Greenwich Community Association Inc

Submission

DA 99/2021

Top Spring Property and Development Services Pty Ltd 21-41 Canberra Ave/18-32 Holdsworth Ave, St Leonards

River Rd – Duntroon Ave Intersection

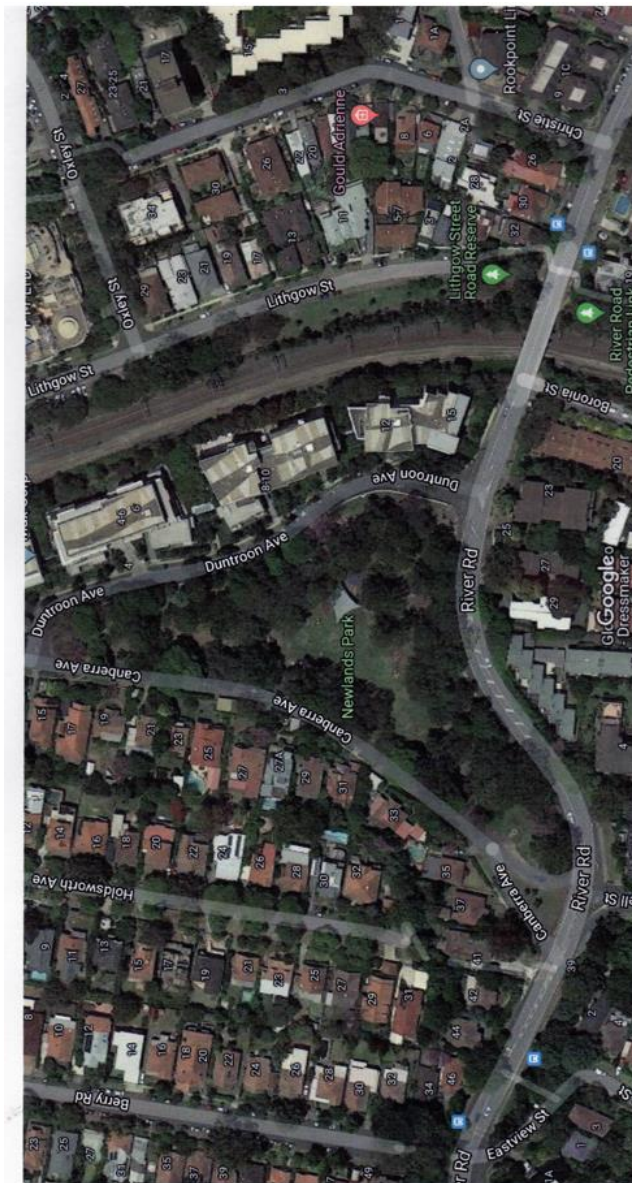
As can be seen from the attached satellite image, the intersection is located adjacent to a sharp downhill steeply sloping S bend to the west, and within 30 metres of an elevated narrow (2 lane) over-rail bridge to the east.

This means that apart from gradient and horizontal curves, sight distance approaching the intersection from both the west and the east along River Rd is severely limited.

Currently there is a very short right hand turn lane from River Rd east into Duntroon Ave and a similarly short queueing lane on River Rd after the intersection for vehicles heading west having turned from Duntroon Ave.

Both of these lanes will be totally inadequate with increased traffic and there is no capacity to safely increase their lengths.

We do not believe that traffic lights will solve the problem given the short sight lines, however a full investigation is needed.
